***And in the*    78 Applications to Take and Use Water in  
*matter of*      the Valetta (55) and Ashburton River (23)  
Groundwater Allocation Zones.**

**Section 42A Officer's Report**

**RESPONSE BY JON WILLIAMSON TO AQUALINC'S RESPONSE TO THE  
COMMISSIONERS REQUESTS FOR INFORMATION  
DATED 12 FEBRUARY and 14 APRIL 2009.**

*Dated:* 18 August 2009

**Figure 1.** Net aquifer-river interaction (negative values indicate net groundwater loss = net groundwater flow to the river).

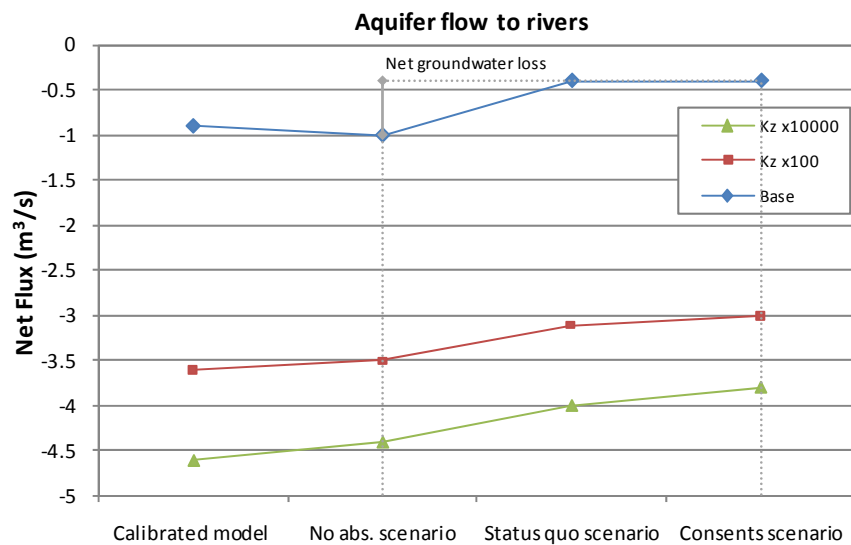
- (c) scale of difference in flux magnitude between models.
- 2.12 **Figure 1** and **Figure 2** assist with this by providing water balance components of the Valetta Zone (only) of the model for: i) net aquifer-river transfers, and ii) net inter-aquifer transfers, respectively. The data in these graphs has been calculated from zone budget information presented in **Appendix C to F** of Aqualinc’s reply. Positive values represent a net groundwater gain in the aquifer, while negative values represent a net groundwater loss from the aquifer.

- 2.13 To assist in evaluating these charts, the following worked example is provided. In **Figure 1**, an example of a relative response would be the differences in net aquifer flow to the rivers between say the “No abstraction scenario” and the “Consent scenario”. For the “base model” this is approximately a  $0.6 \text{ m}^3/\text{s}$ , which represents a reduction in losses from the aquifer (i.e. groundwater flow to the river of  $1.0 \text{ m}^3/\text{s}$  reduces to  $0.4 \text{ m}^3/\text{s}$ ). If we look at the same relative response for the “ $K_z \times 100$  model”, the relative response is approximately  $0.5 \text{ m}^3/\text{s}$  also, while for the “ $K_z \times 10000$  model”, it is approximately  $0.6 \text{ m}^3/\text{s}$ .

- 2.14 When comparing the relative responses overall, the above analysis indicates that the impact on the river does not vary significantly between

models. The implication of this is that varying  $K_z$  in the aquitards does not appreciably impact on the overall budget of transfers to the river under steady state conditions, even though the absolute magnitude in transfers has increased.

2.15 A key consideration for the Commissioners on the later point regarding will be whether the change in absolute magnitude has implications that are a) location specific; and/or b) seasonal. However, it is not possible to evaluate this with the data currently presented.

**Figure 2. Net inter-aquifer transfers** (only flow between aquifers, excludes external transfers).

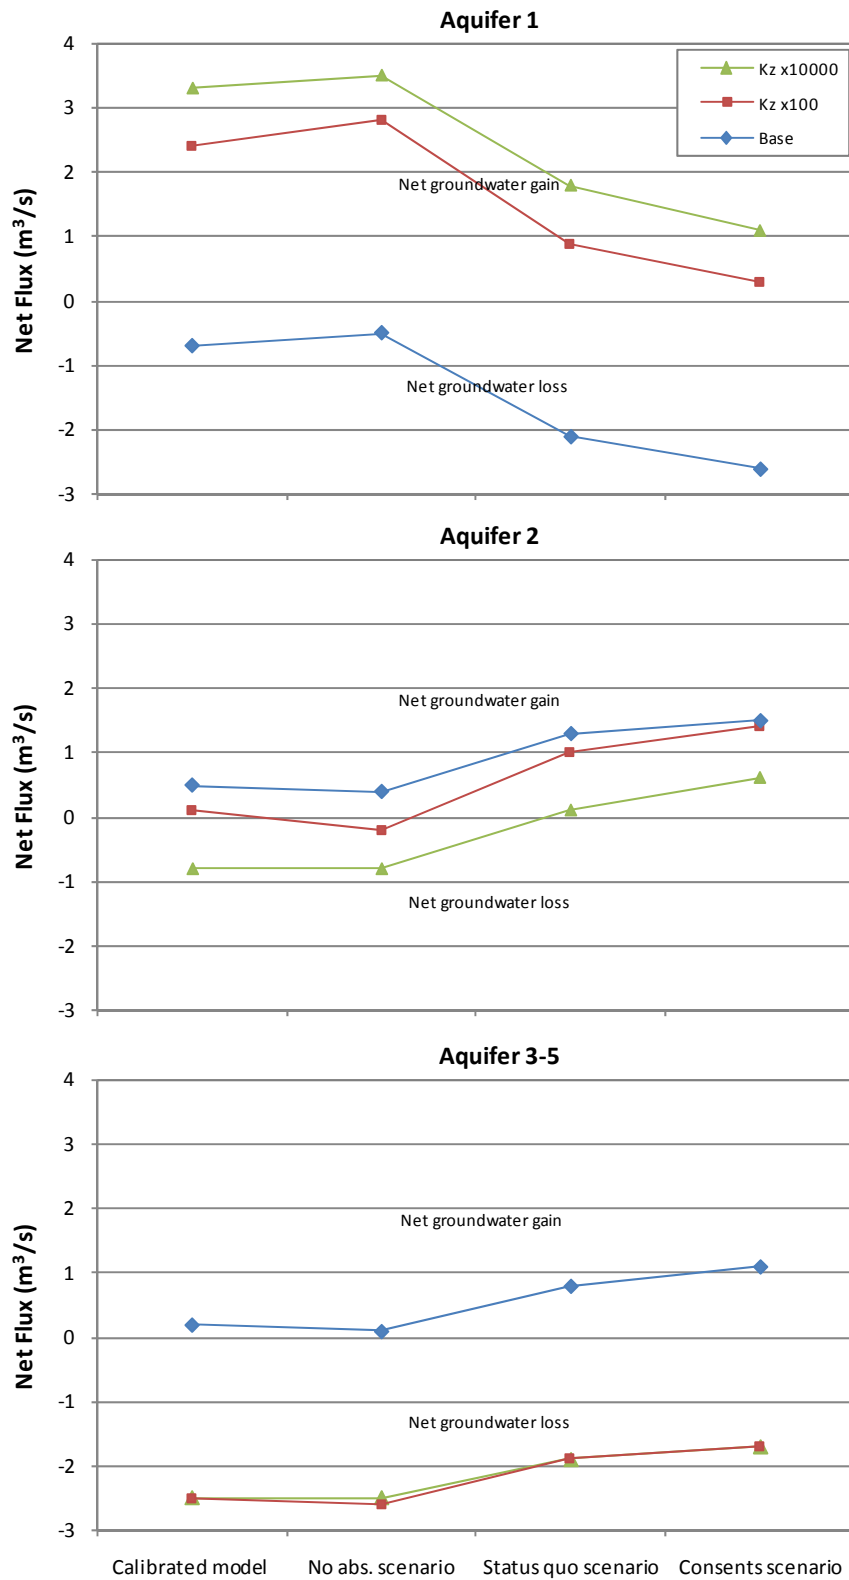
2.16 **Figure 2** provides an analysis of the net groundwater flux or leakage between vertically adjacent aquifer zones. The computed data assesses only groundwater transfers between layers (i.e. no external or lateral transfers). Again, positive values represent a net groundwater gain within that aquifer, while negative values represent net groundwater loss from that aquifer. **Appendix A** provides the datasheets for these calculations.

2.17 With increased abstraction the net overall groundwater loss from Aquifer 1 increases under each scenario. What is interesting is that the relative response is similar for each model (i.e. it makes no difference whether we assess the results from the calibrated model or the new models).

- 2.18 However, what is different between models is the absolute magnitude in net fluxes. With increasing  $K_z$  in the models, the net gain in groundwater in the shallow aquifer from the underlying aquifers increases significantly. This is because the impedance to vertical flow has been removed and the vertical pressure gradients now permit flow to transfer from the deeper aquifers to the shallow. Given the observed head increases in the deeper bores of the mid to upper plains area and the steepened hydraulic gradient between the river and shallow aquifer, this upward migration of groundwater is likely to be occurring predominantly in the mid to lower areas of the plains.

- 2.19 The response observed in the steady state simulations is more realistic in my view than the previous model, but the new models need re-calibrating (as discussed above) to enable reliance on actual values suggested by the model.
